DOMINION ENERGY KEWAUNEE, INC.  
KEWAUNEE POWER STATION  
LICENSE RENEWAL DRAWING  
ELECTRO - HYDRAULIC CONTROL  
& LUBE SYSTEM

APPROVED	DRAWN	DATE	REV.
	JSM	1/24/00	0
REVIEWED	SCALE	LRXK-101-24-1

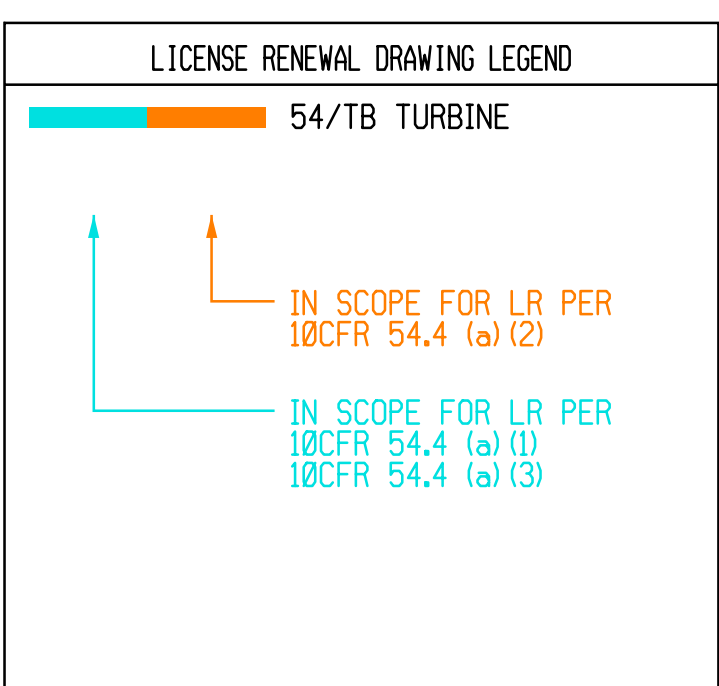
DISCONNECT PIPING ABOVE & BELOW HYDRAULIC CYLINDER ON EACH VALVE. THIS REMOVES SOLENOID VAVLE & ACCUMULATOR UNWIRED VIA DCR 1008 INSTALL BLANK FLANGES WITH ETHYLENE O-RING.

LR NOTES:  
1. THE COMPONENTS ARE LOCATED INSIDE THE TANK AND NOT INCLUDED IN LR SCOPE FOR SPATIAL CRITERIA.
